# VALUE ENGINEERING WORKSHOP

## WIDENING SR17 – IMPROVEMENTS PROJECT EDS 545 (43) Warren & McDuffie Counties, Georgia

24 August 2006

**SUMMARY OF RECOMMENDATIONS  
EDS 545(43) SR – 17 IMPROVEMENTS  
24 AUGUST 2006**

# PROPOSED CHANGE SKETCH/DETAIL

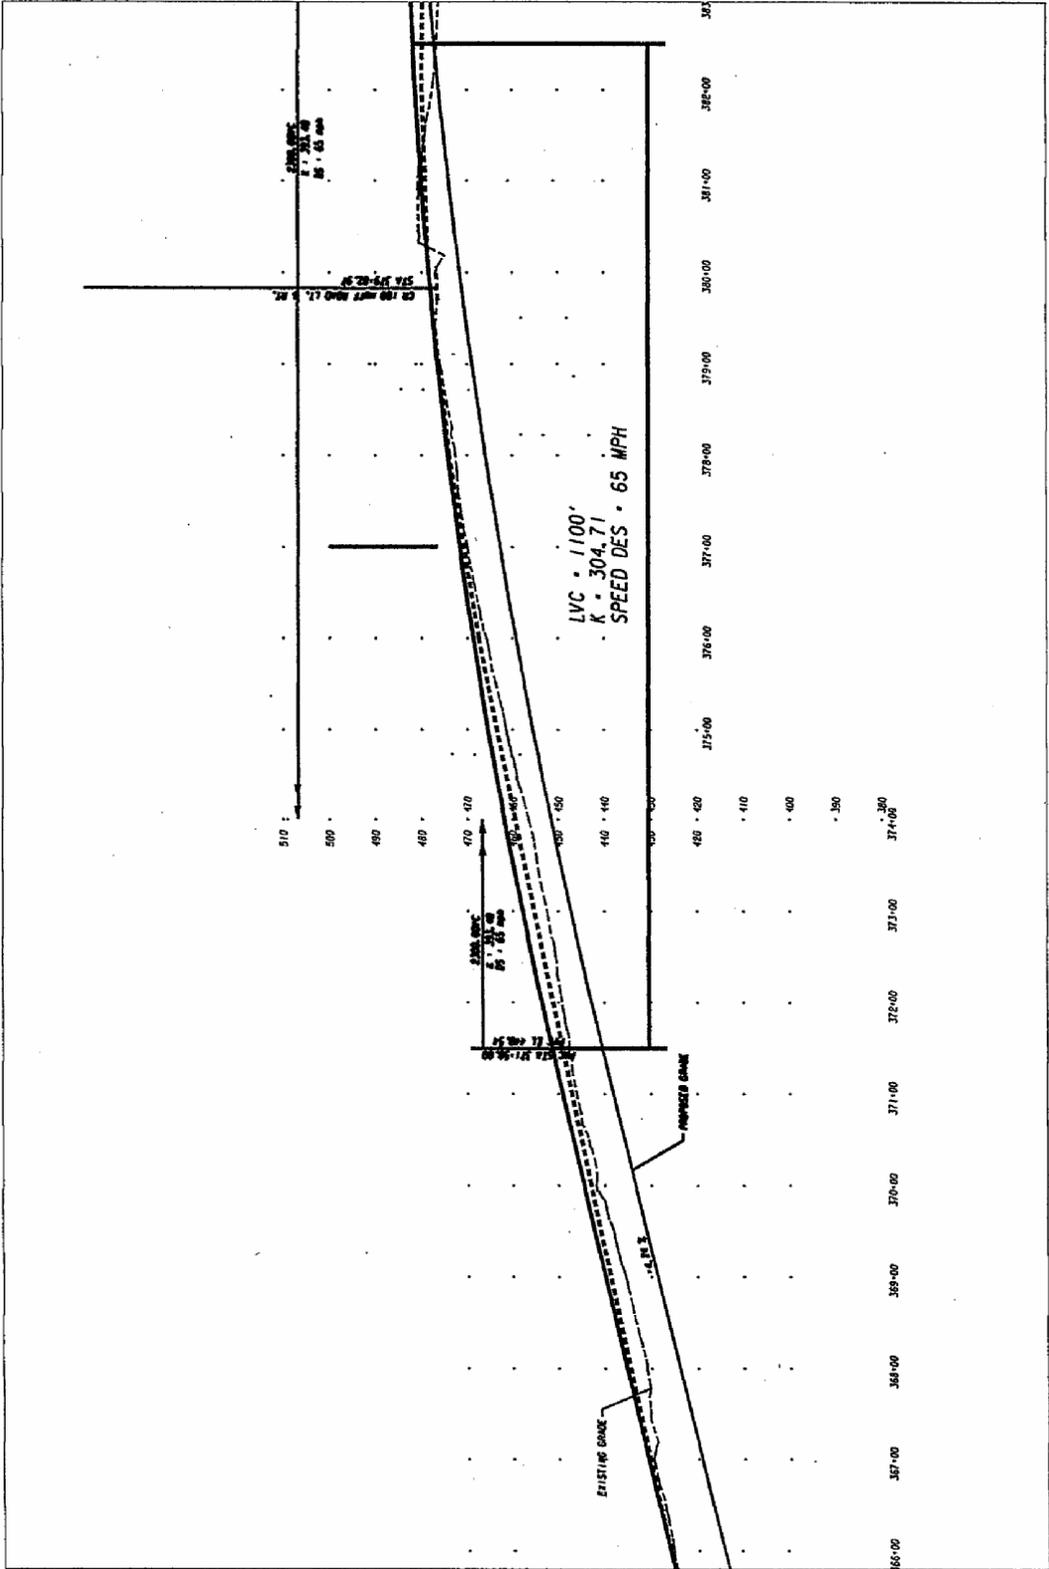
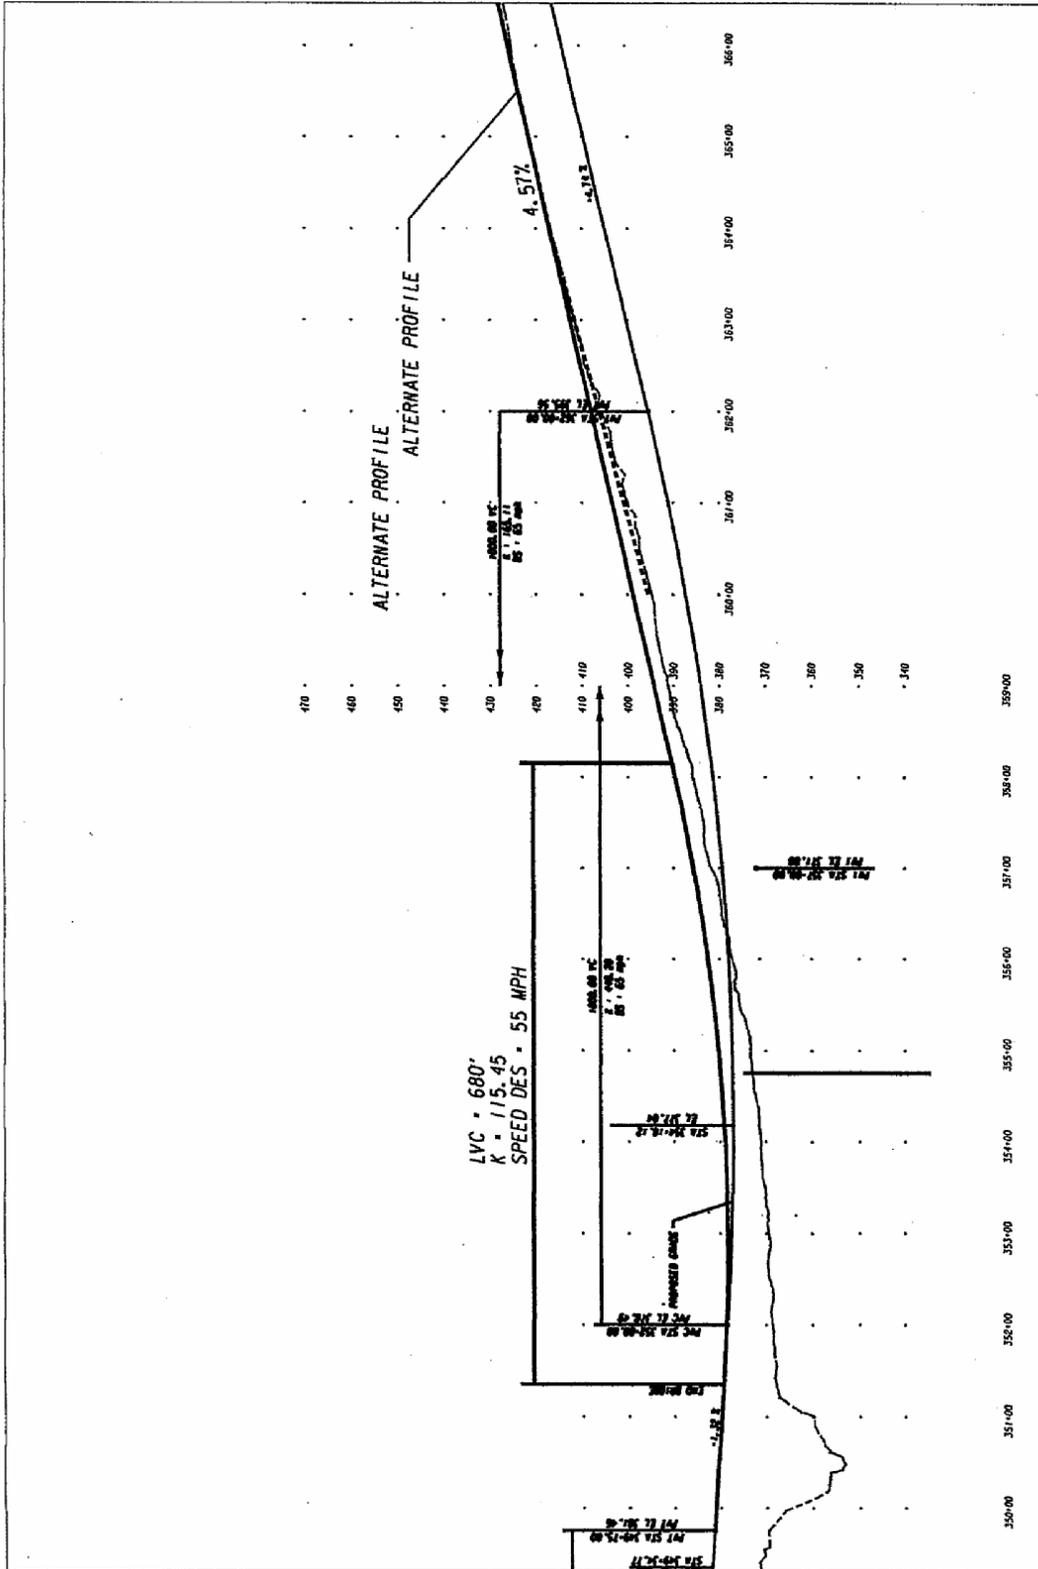
**PROPOSAL DESCRIPTION:** MODIFY PROFILE TO REDUCE  
EARTHWORK STA. 351+00 TO STA. 410+00  
(IMPROVES CONSTRUCTABILITY AND  
IMPROVES MAINTENANCE OF TRAFFIC  
DURING CONSTRUCTION).

**ORIGINAL DESIGN:** The original design profile leaves the Reedy creek bridge @ -  
1.32% grade followed by a 1000' sag vertical curve then a grade tangent of +4.74% followed by  
a 2300' crest vertical curve to PVT sta. 394+50 where a -1.11% grade begins.

**PROPOSED CHANGE:** The proposed change recommendation is to modify the profile  
from sta. 351+00 to sta. 414+00 by placing a 55 mph sag vertical curve immediately adjacent to  
the bridge over Reedy Creek and raising the grade tangent to 4.57%. Use two crest vertical  
curves @ 65 mph speed design separated by a 950 foot grade tangent in lieu of one long vertical  
curve at sta. 383+00. This more closely follows the existing road profile reducing the two cuts  
by ± 169,000 c.y.

# PROPOSED CHANGE SKETCH/DETAIL

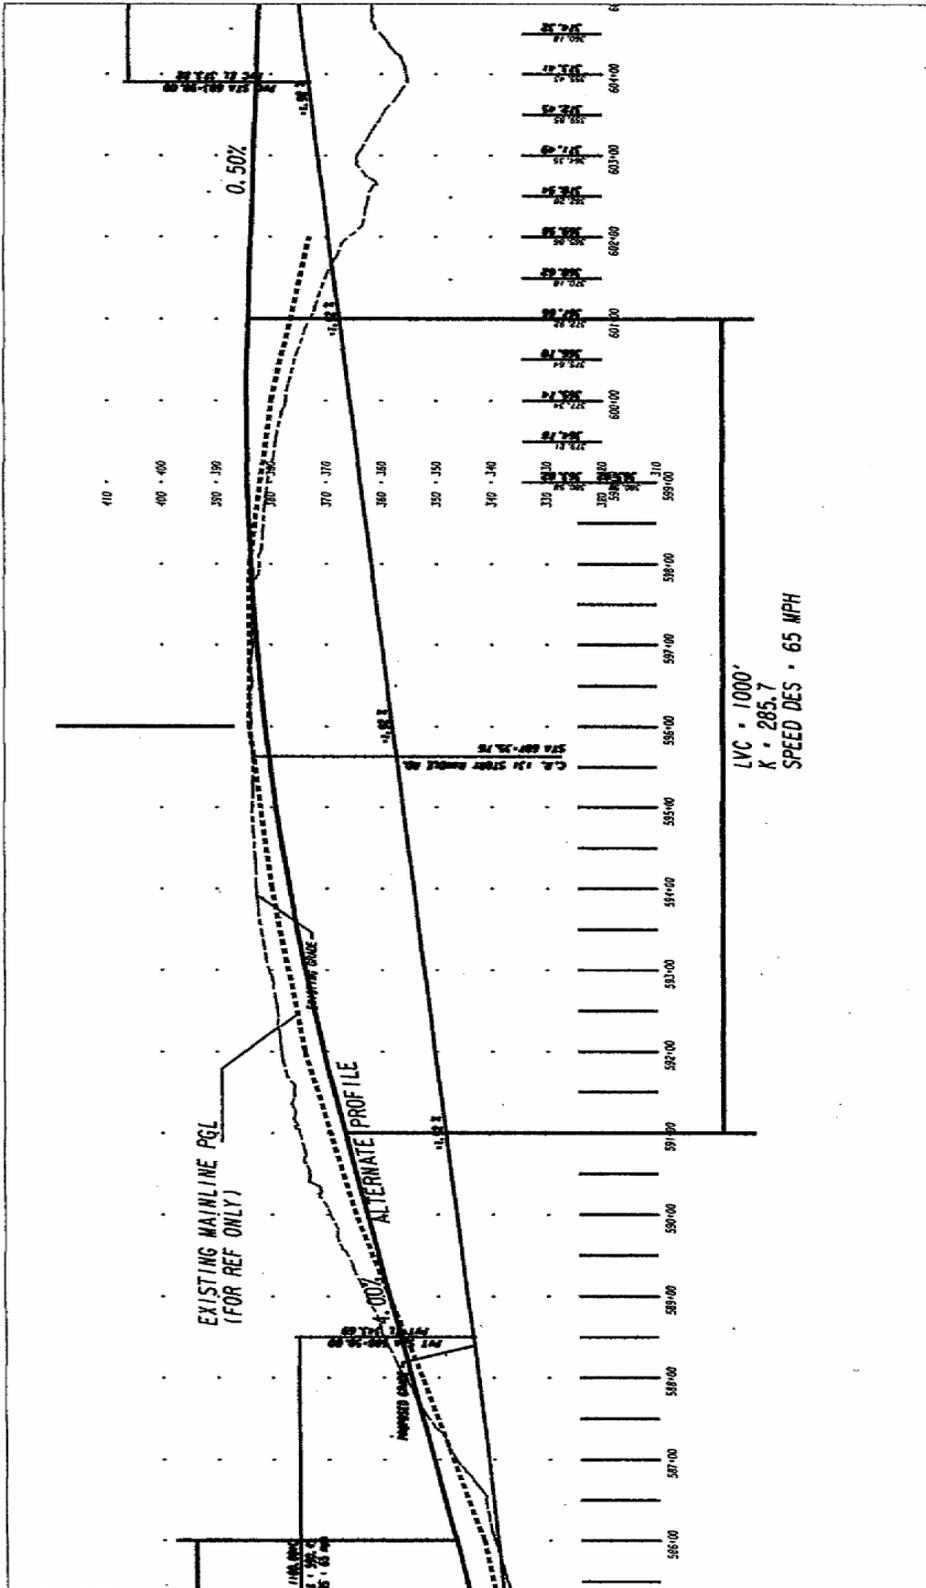
**PROPOSAL DESCRIPTION:** MODIFY PROFILE TO REDUCE  
EARTHWORK STA. 546+00 TO STA. 628+00  
(IMPROVES CONSTRUCTABILITY AND  
IMPROVES MAINTENANCE OF TRAFFIC  
DURING CONSTRUCTION).

**ORIGINAL DESIGN:** The original design profile utilizes a -1.04% grade tangent approaching the bridge over Little Brier Creek resulting in cuts approaching 40 feet. North of the bridge at 1.92% grade result in cuts up to 28 feet.

**PROPOSED CHANGE:** The proposed change recommendation holds the profile on the bridge over Little Brier Creek and immediately south of the bridge uses a -5% grade and two vertical 55 mph curves (1 sag & 1 crest) to reduce the cut section from sta. 557+00 to sta. 572+00. North of the bridge use a 4% grade and two 65 mph ea. Vertical curves (1 sag & 1 crest) in lieu of 1.92% grade.

# PROPOSED CHANGE SKETCH/DETAIL

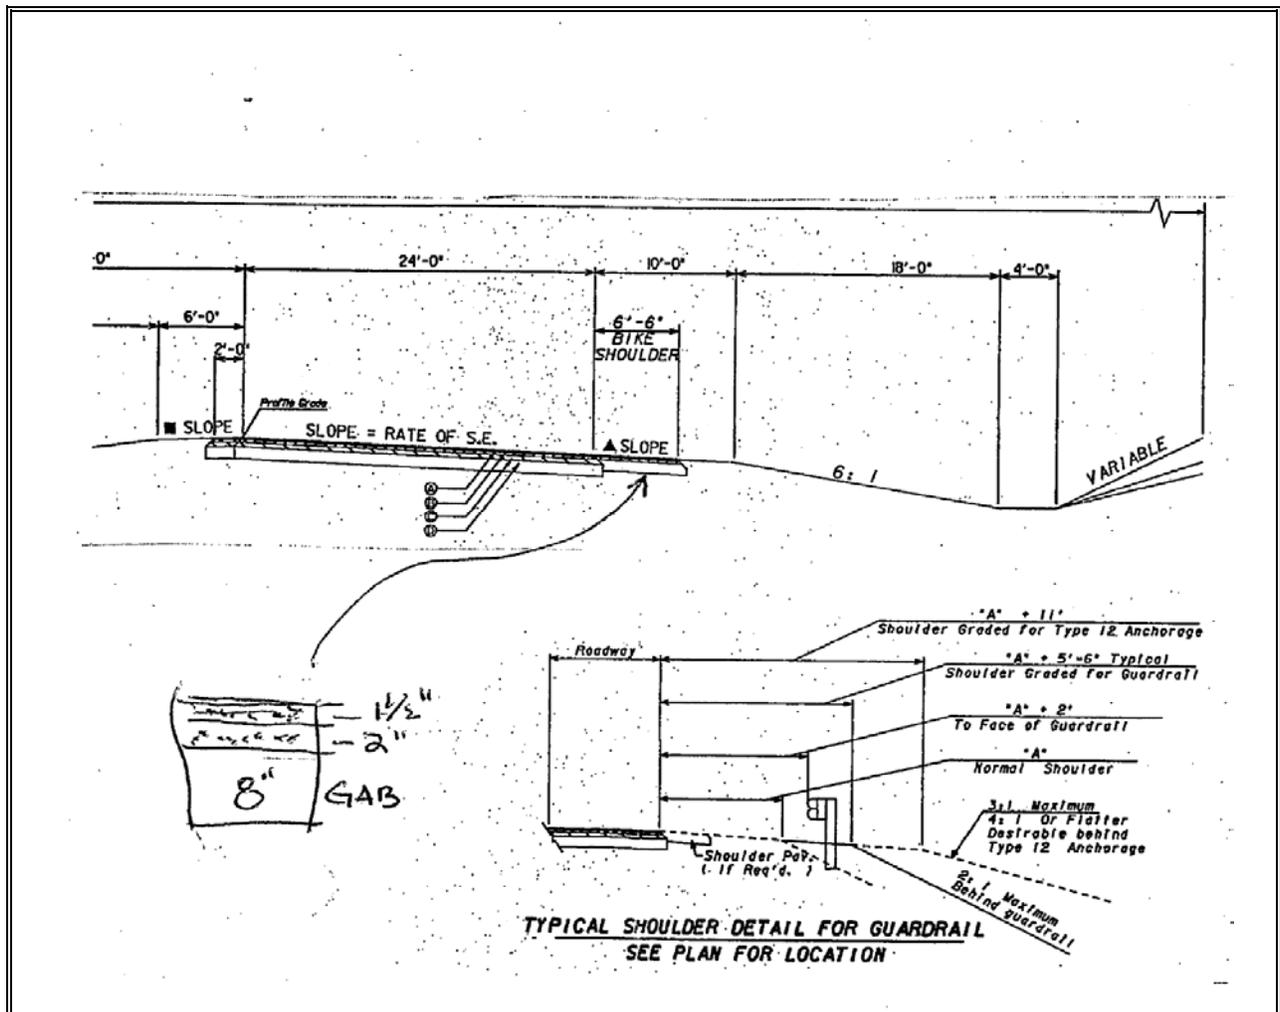
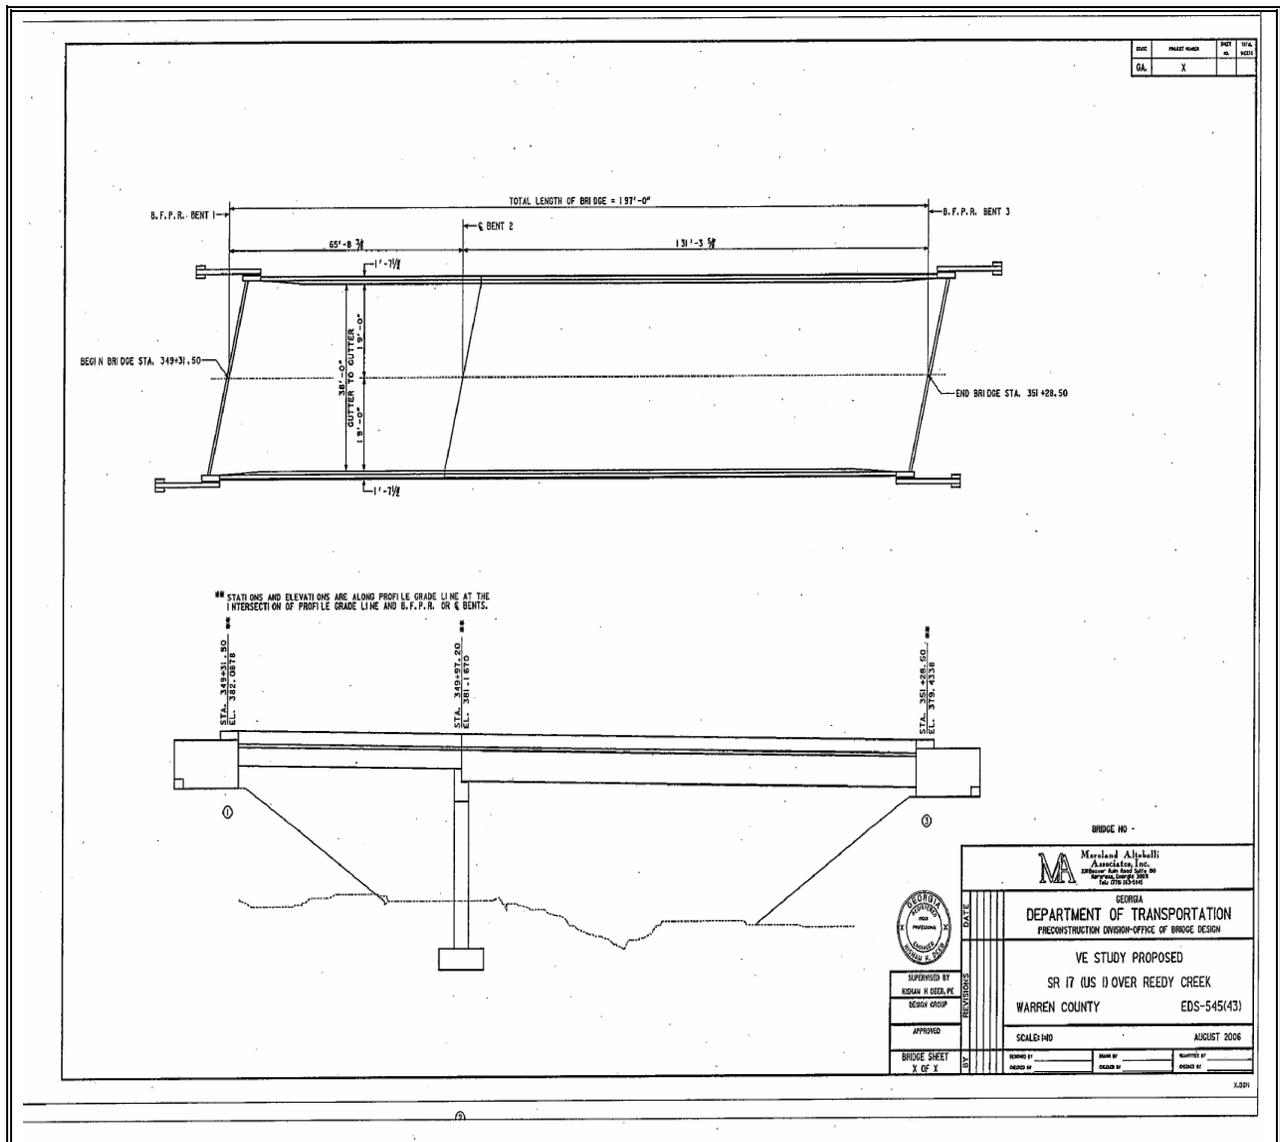
**PROPOSAL DESCRIPTION:** REDUCED PAVEMENT DEPTH OF OUTSIDE  
PAVED SHOULDERS.

**PROPOSED CHANGE:** The proposed change recommendation is to reduce the outside shoulder pavement thickness to 8" GAB, 440 #/SY of 25 mm, and 135 #/SY of 9.5 mm Asphaltic concrete Superpave.

# PROPOSED CHANGE SKETCH/DETAIL

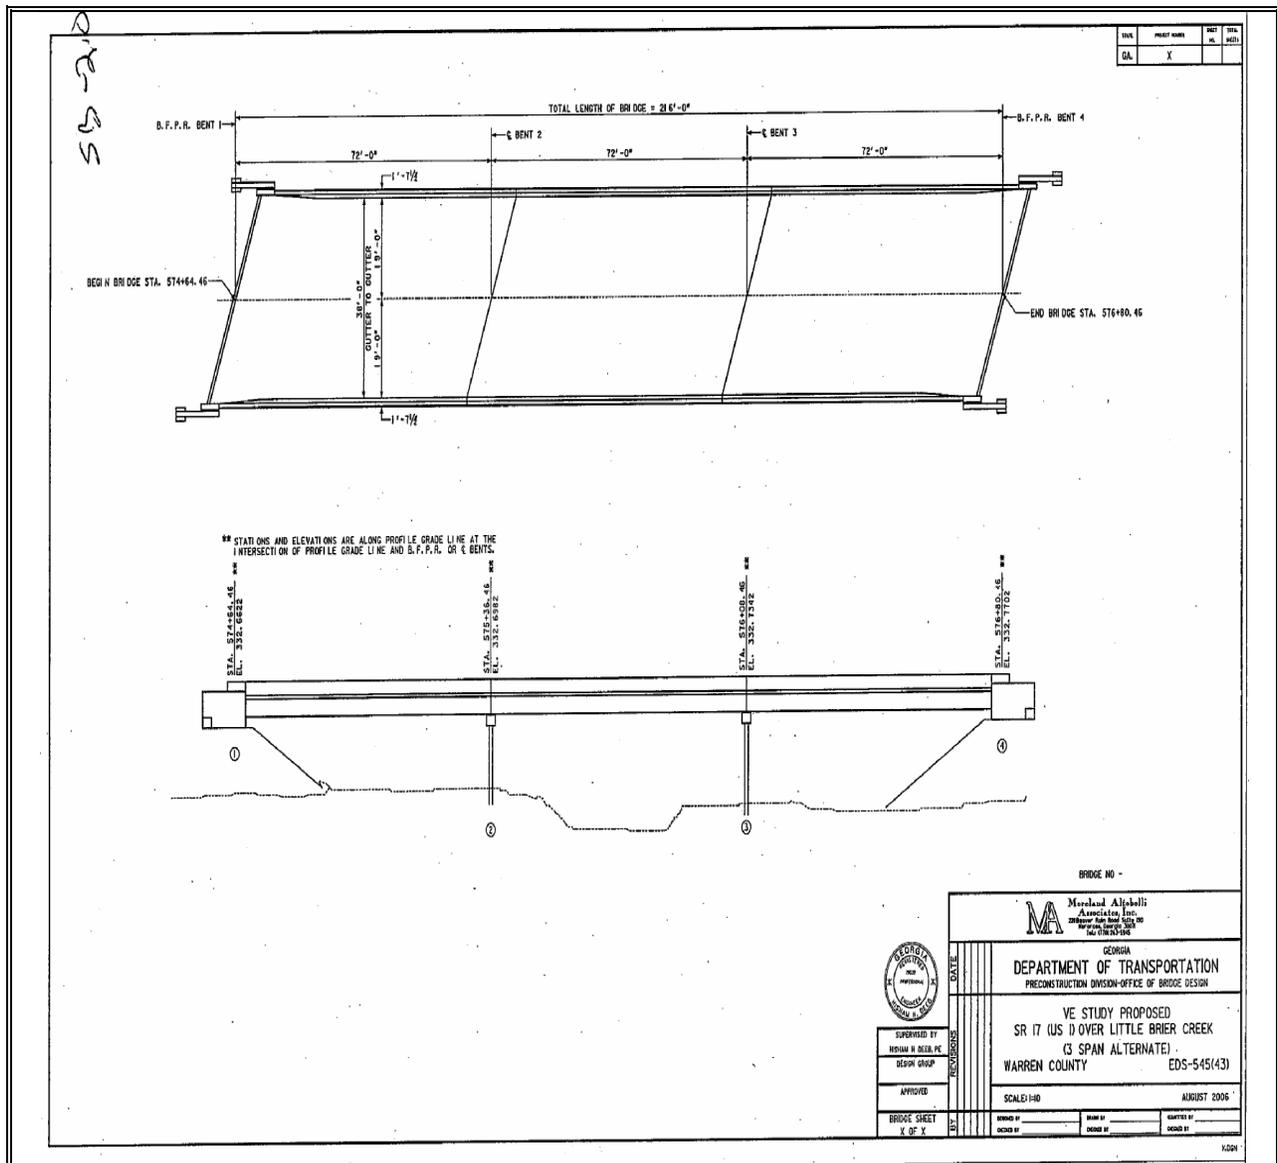
**PROPOSED CHANGE:** The proposed design intends to optimize the design by utilizing 3-spans Type II (72'-0") in lieu of 6-spans T-Beam (36'-0" EA.). The design will enhance the hydraulic opening by eliminating three intermediate piers which would expedite the construction process as well as reduce cost. Since the difference in elevations between the floodstage and the beam bottom chord is generous a Type II PSC Beam superstructure can be accommodated and not in disagreement with the guidelines. PSC pile bents can be designed for large spans and TYPE II PSC beams with HPC concrete can extend over 70' spans. The change is feasible.

# PROPOSED CHANGE SKETCH/DETAIL

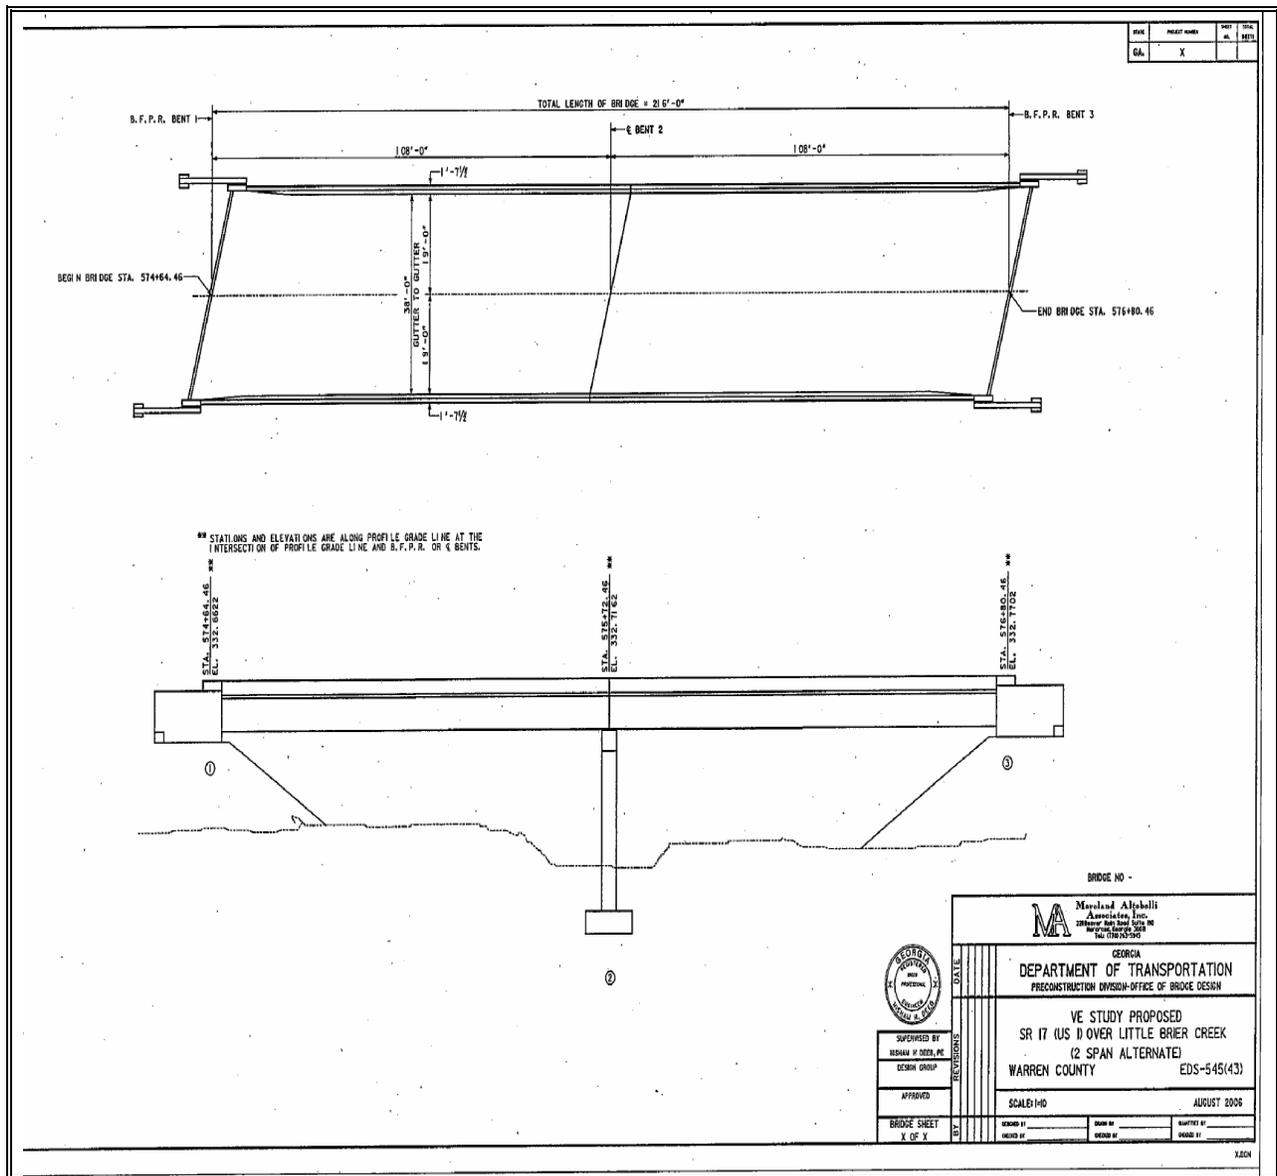
<b>ORIGINAL DESIGN:</b>	The original design proposes the same span arrangements as the existing bridge over Little Brier Creek (Six 36'-0" spans) with T-beam superstructure and five intermediate pile bents.
<b>PROPOSED CHANGE:</b>	The proposed design intends to optimize the design by utilizing 2-span BT 54in (108'-0" EA.) in lieu of 6-spans T-Beam (36'-0" EA.). The design will enhance the hydraulic opening by eliminating four intermediate piers which would expedite the construction process as well as reduce cost. Since the difference in elevations between the floodstage and the beam bottom chord is generous a BT 54in Beam superstructure can be accommodated and not in disagreement with the guidelines. The change is feasible.
